**General Implementation Plan  
Fitchburg Technology Campus**

Fitchburg, Wisconsin

Revised: May 21, 2002

## GIP Comment Summary

# General Implementation Plan

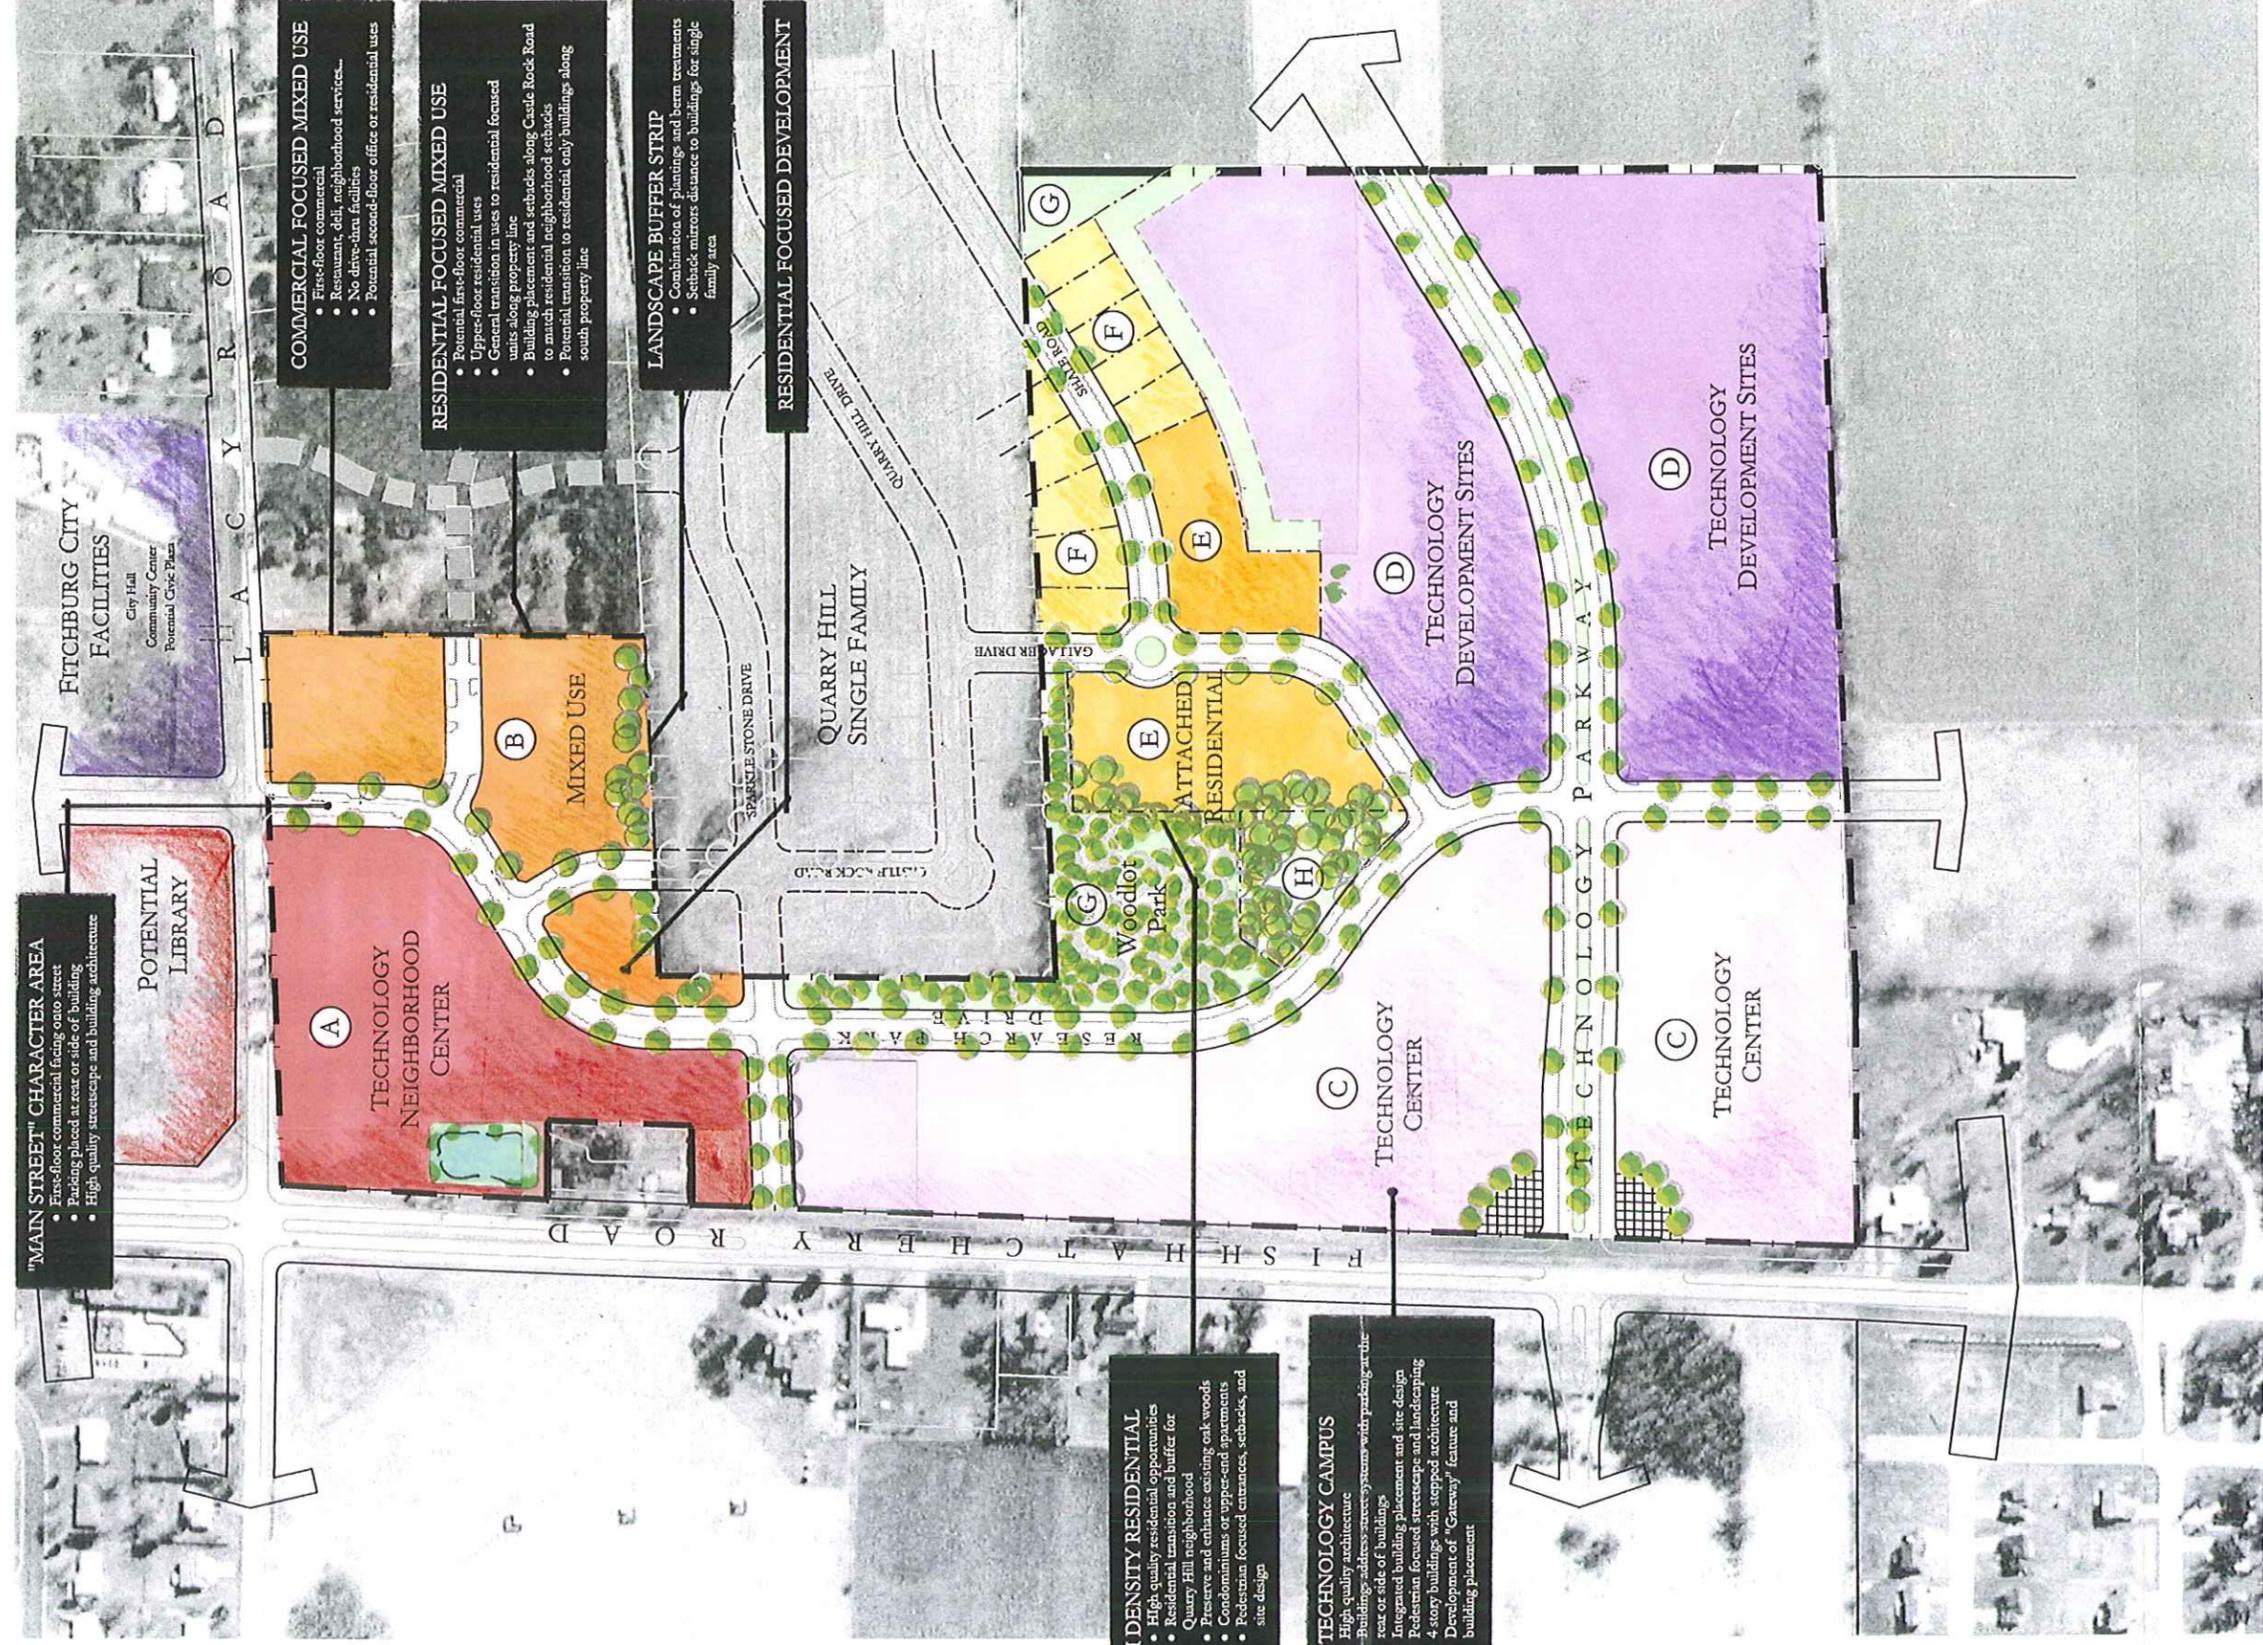
12. Building setback of 175 feet from Sparkle Stone conflicts with your p. 19 Building Envelope plan.

THE GIP TEXT WILL BE REVISED TO NOTE THIS REVISION.

General Implementation Plan Acreage Breakdown

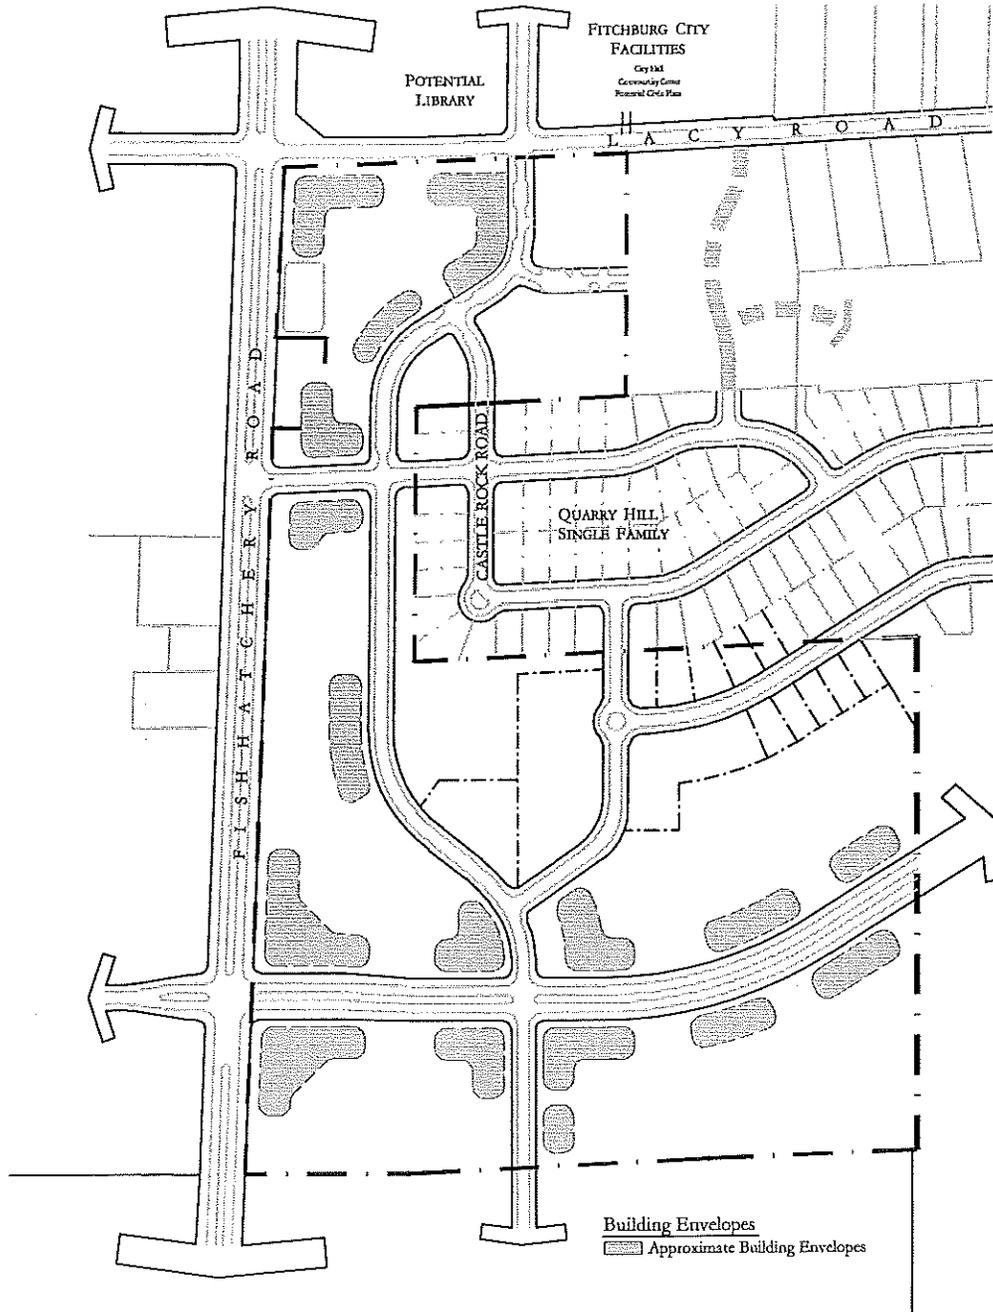
1. Provide lot and parcel sizes for each lot or parcel within the plat.

THE REVISED BREAKDOWN CHART COVERING DISTRICT TO LOT NUMBERS, AND DEVELOPMENT ACREAGE, SQUARE FOOT, TRAFFIC GENERATION, AND PARKING BREAKDOWNS WAS SUPPLIED TO STAFF. THIS INSERT CHART WILL REPLACE THE BREAKDOWN SHEET INCLUDED IN THE GENERAL DEVELOPMENT PLAN (GIP) (PAGE 18).
